TECHNICAL BULLETIN

407-20-134

MODEL AFFECTED: 407

SUBJECT: ENGINE TORQUE INDICATION SYSTEM,
MODIFICATION OF

FIGURE 1 – Terminal block, rail, and wire harness installation

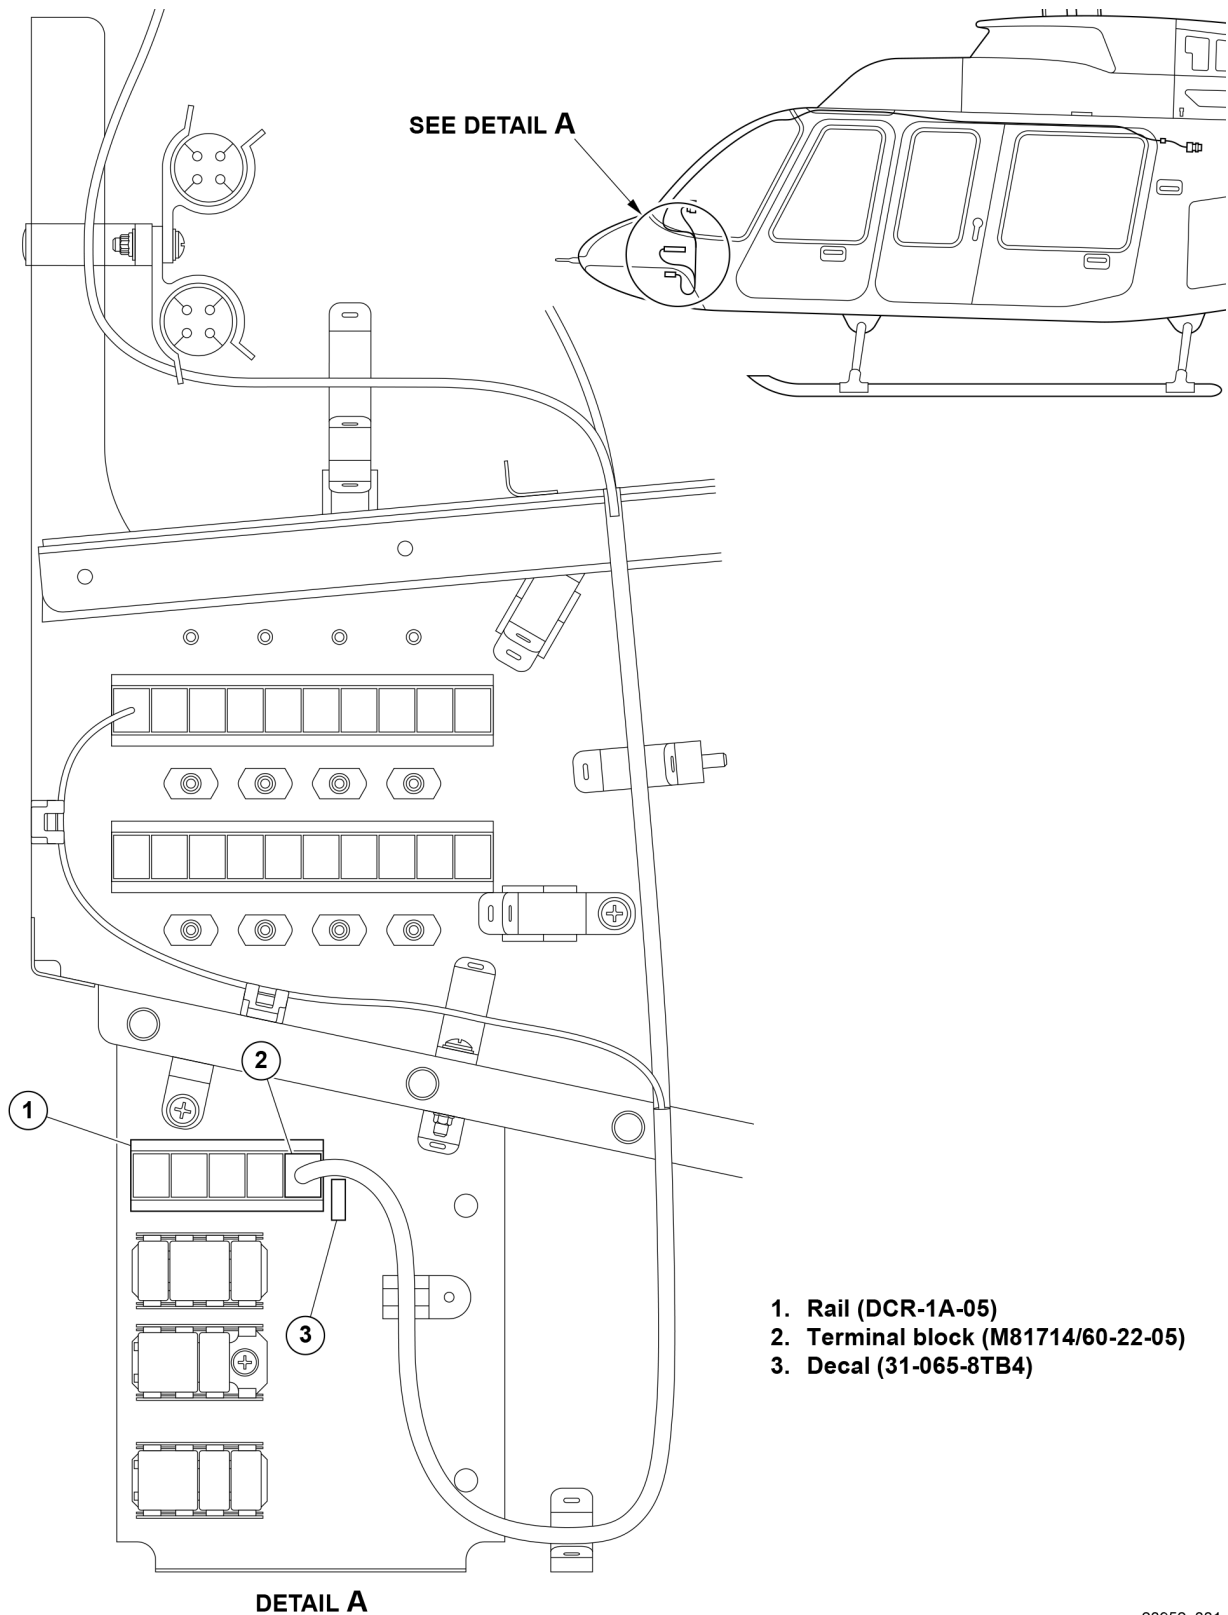
7. Install the new rail (1, Figure 1) with the hardware that was retained in step 6, and bond the decal (2), as shown in figure 1.
8. Install the new terminal block 8TB4P (3) on the rail (1) and reinstall the terminal blocks 8TB4K, 8TB4L, 8TB4M and 8TB4N that were removed in step 5 (BHT-ELEC-SPM).

Refer to BHT-ELEC-SPM to complete the following step. Refer to Figure 1 for wire routing and Figure 2 for the wiring diagram.

FIGURE 2 – Torque transducer modification wiring diagram

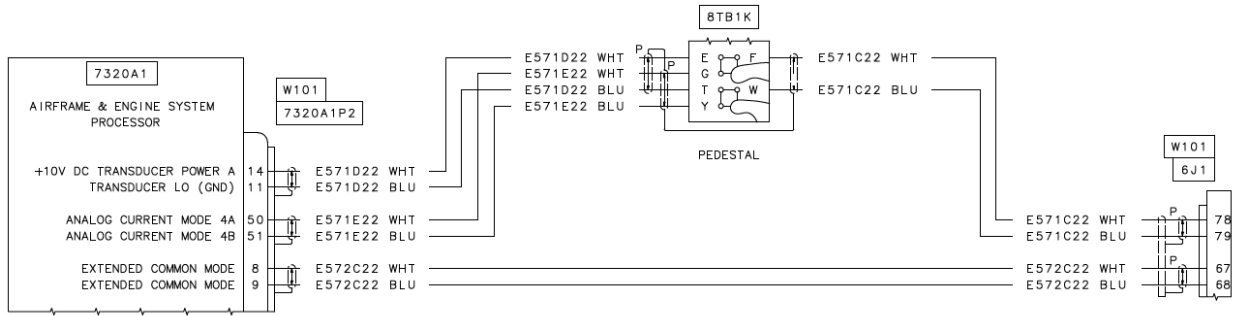
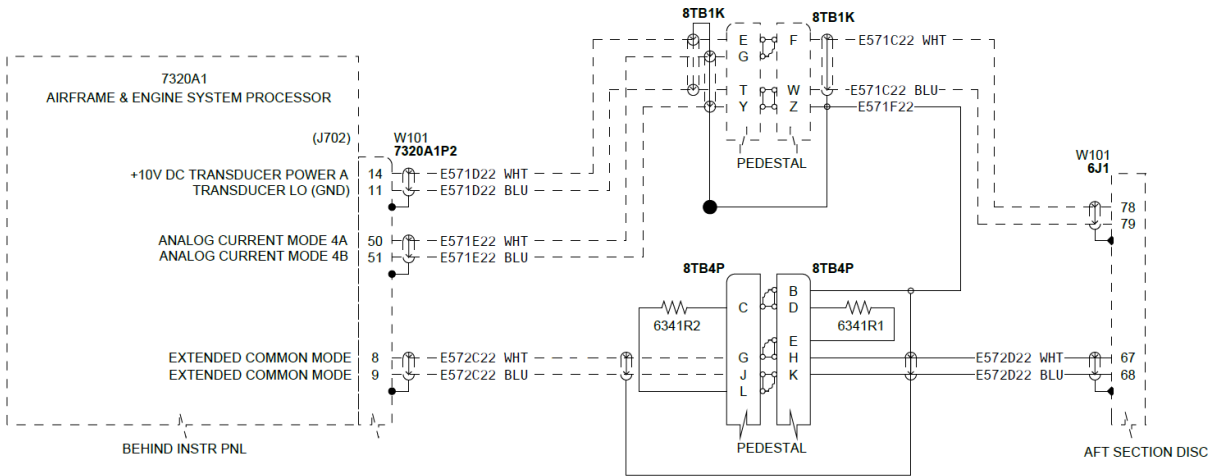
Bell has discovered that the 407 GXi helicopter engine torque indication system is over indicating by 1.6% on the whole span of the engine torque measurement.

This technical bulletin provides the instructions to modify the engine torque indication system with the installation of balancing resistors to the engine torque transducer circuitry. The function of the balancing resistors is to stabilize the engine torque signal output.

- i. Terminate wire E572C22, E571F22 and E572D22 to terminal block 8TB4P using contact M39029/22-191. Shield wires E572C22, E571F22 and E572D22 shall be terminated together at the terminal block 8TB4P using shield terminator S200-3-00, S200-2-W1-22-9 and S200-3-W1-22-9 respectively.

- j. Insert wire E572C22 white and blue to terminal block 8TB4P position G and J respectively.
 - k. Insert wire E571F22 to terminal block 8TB4P position B.

- l. Insert wire E572D22 white and blue to terminal block 8TB4P position H and K respectively.
 - m. Identify 6341R1 and 6341R2 to the resistors 110-182H1004TAM by using the insulation tube 130-061-02W2 and a permanent ink marker.

- n. Insert resistor 6341R1 to terminal block 8TB4P position D and E
 - o. Insert resistor 6341R2 to terminal block 8TB4P position C and L.
10. Reinstall the left upper and lower console panel, and left upper door. (407-MM, chapter 95 and BHT-ALL-SPM)
